**TOWN OF FAIRFAX
STAFF REPORT**
Department of Planning and Building Services

TO: Fairfax Planning Commission
DATE: July 16, 2020
FROM: Linda Neal, Principal Planner
LOCATION: 572 Cascade Drive; Assessor's Parcel No. 003-022-20
PROJECT: New single-family residence and driveway improvements
ACTION: Hill Area Residential Development, Excavation, Tree Removal and Design Review permits; Application # 20-4
APPLICANT: Richard Rushton, Architect
OWNER: George Pederson
CEQA STATUS: Categorically exempt, §15303(a)

572 CASCADE DRIVE

A Resolution of the Fairfax Planning Commission Approving Application No. 20-4 for a Hill Area Residential Development, Excavation, Tree Removal and Design Review Permits for a Residence at 572 Cascade Drive

Street View

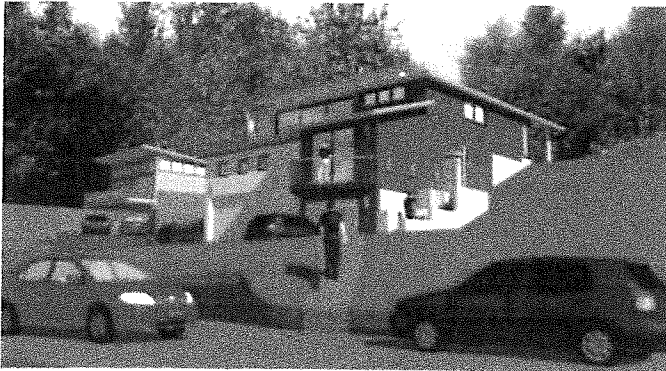
The primary concern of the Planning Commissioner's comments was the 3-story height facing the street. While the face of the building is set back more or less 50 feet from the edge of the road paving, the height at the entire front wall has been reduced to 2 stories. This reduces the scale of the building as it appears from the street. This revision has been achieved without redesigning the floor plan, by simply pushing the 3rd floor plan northward by 12', giving the building stepped appearance. The kitchen area is now located in the area previously used by the northerly patio, and the patio area is instead located just to the east of the kitchen. The patio area is covered to provide shade from the summer sun.

The step-back design is most effective as seen from the street. And as before, the Fruitless Olive trees, 10' high at 5-year growth, provide an effective visual screen. Even without the trees shown, the building volumes are differentiated by pattern, color, height and shadows. Transparent railings relieve the apparent height.

PRELIMINARY SITE IMPROVEMENT PLAN
SCALE: 1/8" = 1'-0"

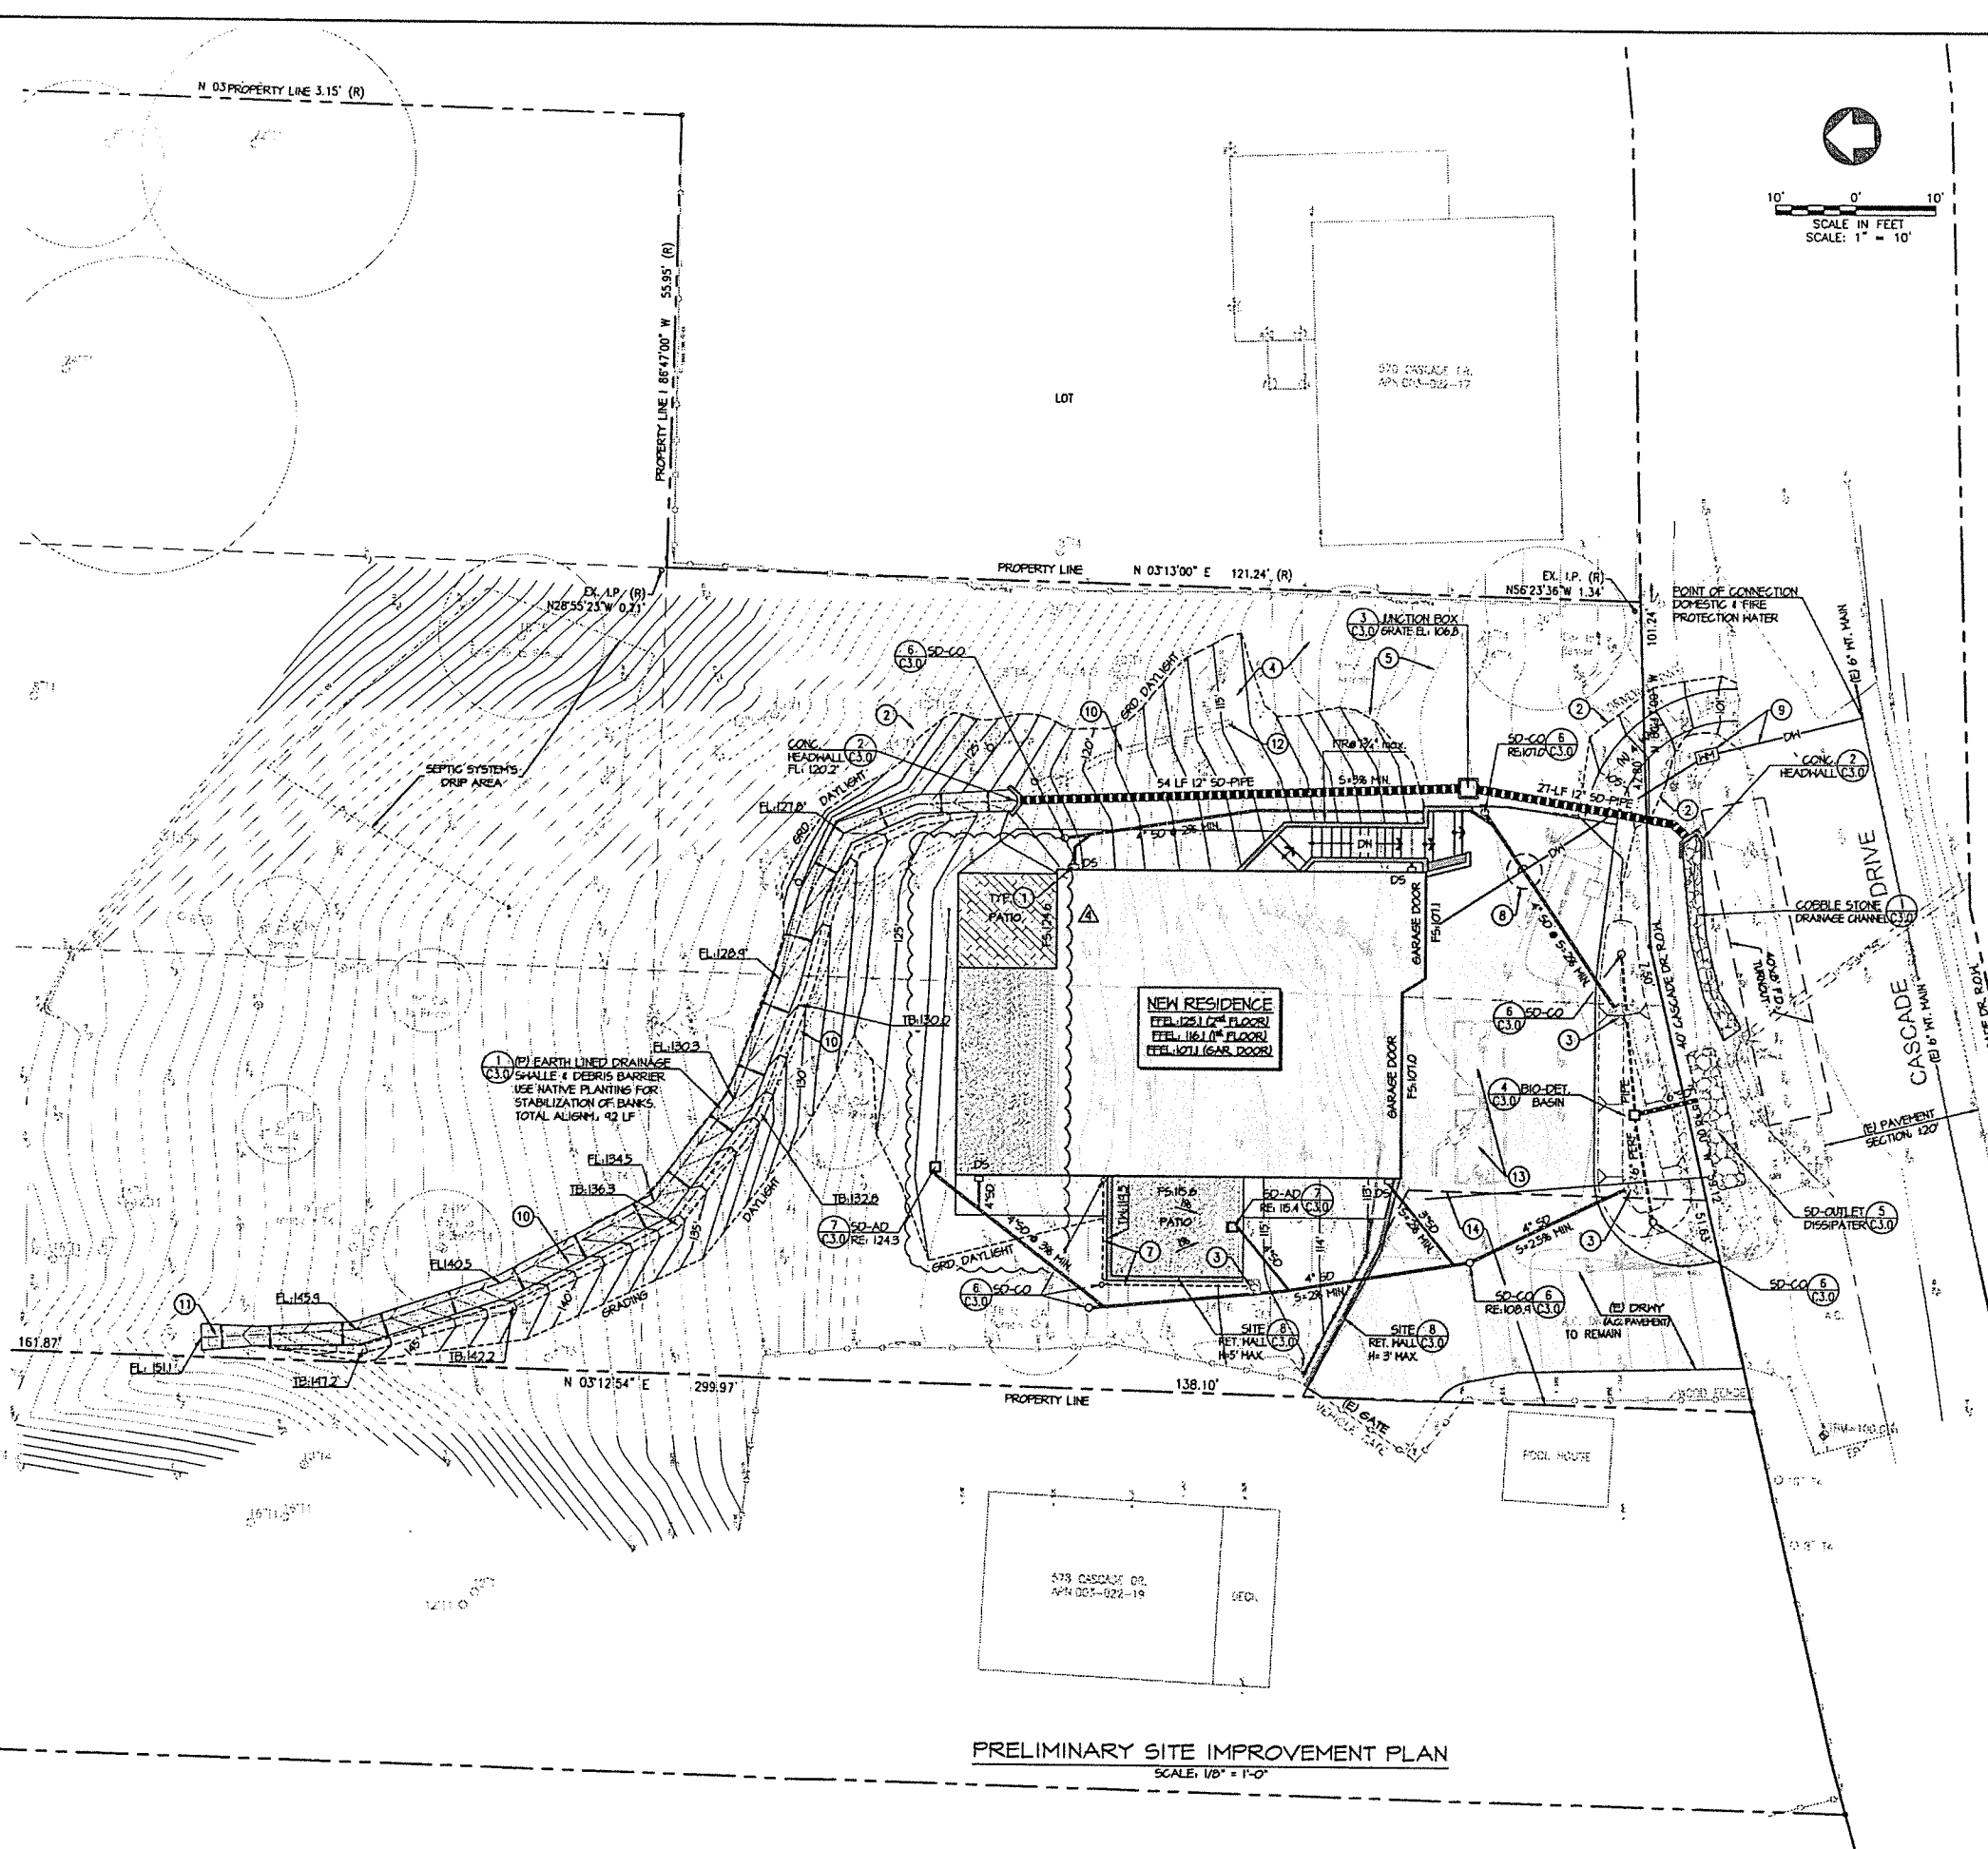
6. The amount of grading and off-haul have not been minimized so consideration should be given to making design changes to decrease the amount of grading and the off-haul of material.

1. Site Grading Plan has been revised to accommodate the revised footprint of the residence. The earthwork quantities have been subsequently changed to reflect the new site plan. Please see plan sheet C3.0.
2. Consideration has been given to the traffic associated with hauling off-site the excavated material during construction. In addition to the considerable reduction in soil being proposed to be off-hauled from the site, this activity will be scheduled over an extended period of time, in a manner that will not create disturbance to the traffic.
3. The Landscape and Vegetation management plan have been revised to show additional trees proposed to be planted in order to compensate for the healthy trees being removed during the demolition phase of the project. Please see L1.0 and L1.1 sheets.
